Applicant: SkyWater Technology Foundry, Inc.

Location: 2401 and 2411 East 86th Street

Request: 1) Rezone from CO-1(PD) (AR-17) to IT (PD) (AR-17)
2) Major Revision to Preliminary Development Plan and Final Development Plan for an Expansion

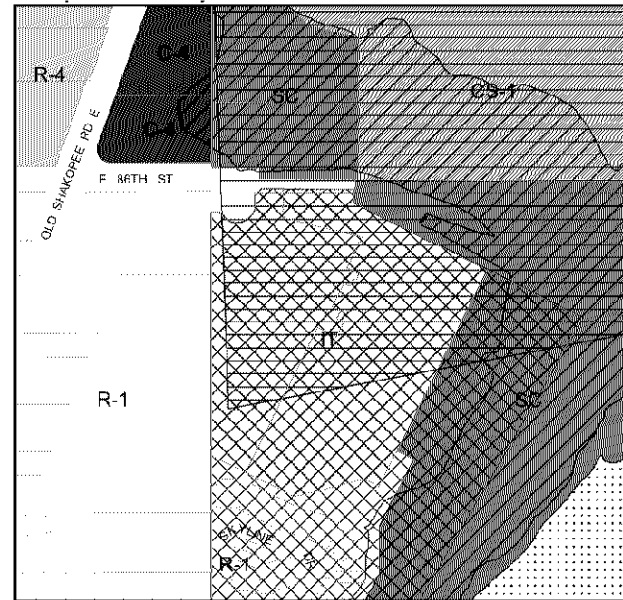
Staff believes the proposed base zone change and preserving the planned development overlay, as depicted in Graphic 1 below, is consistent with the Comprehensive Plan and provides a public benefit by implementing the Comprehensive Plan and South Loop District Plan. As part of the 2019 Planning Commission work plan, the City intended to initiate rezoning of this parcel, along with others, to IT.

Existing Zoning

Proposed Zoning
